Product Change Notification / ASER-06ZMCM207

CCB 4630 Final Notice: Qualification of STA as an additional assembly site for selected LAN9303, LAN9210 and LAN9211 device families available in 56L VQFN (8x8x0.9mm) package.

CCB 4630
Pre and Post Change Summary
PCN #: ASER-06ZMCM207

Lead frame Comparison

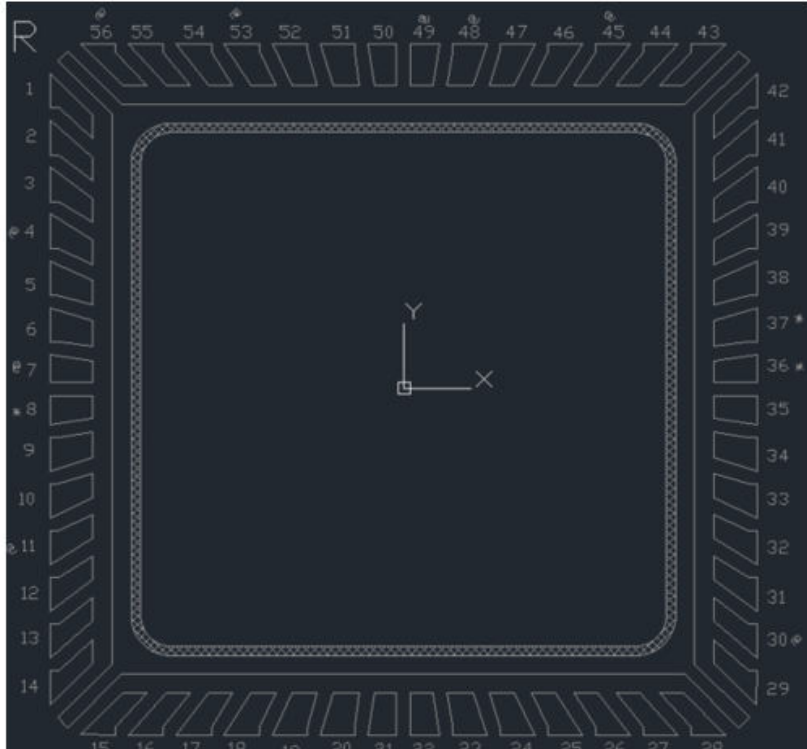
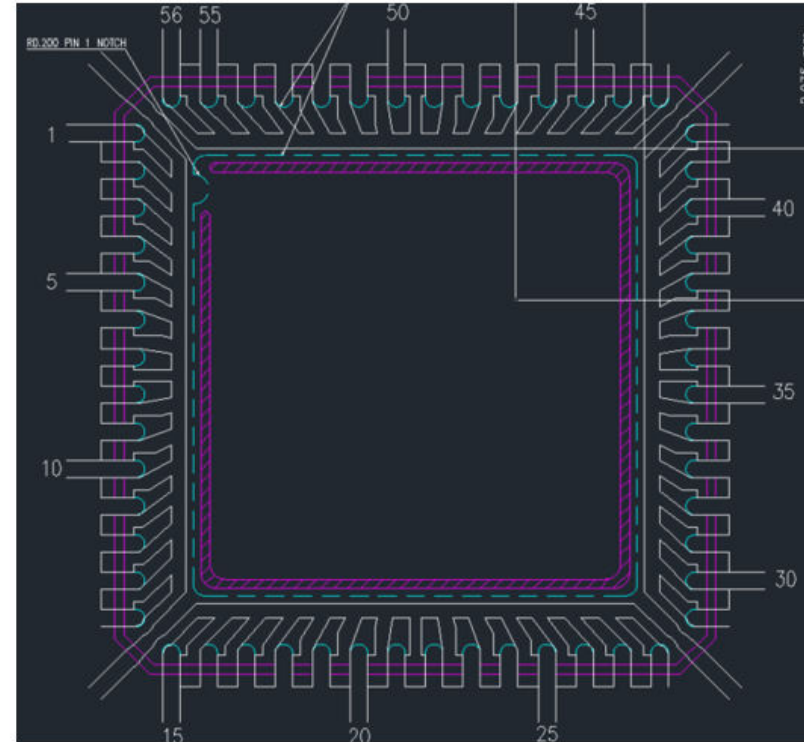
Wire material	PdCu	Au	PdCu	Au	CuPdAu
Die attach material	EN-4900F		EN-4900F		8290
Molding compound material	G631B		G631B		G700E
Lead frame material	C194		C194		C194
Lead frame lead-lock	No		No		No
	See Pre and Post Change Summary for comparison.				
Lead frame paddle size	240x240 mils		240x240 mils		236x236 mils
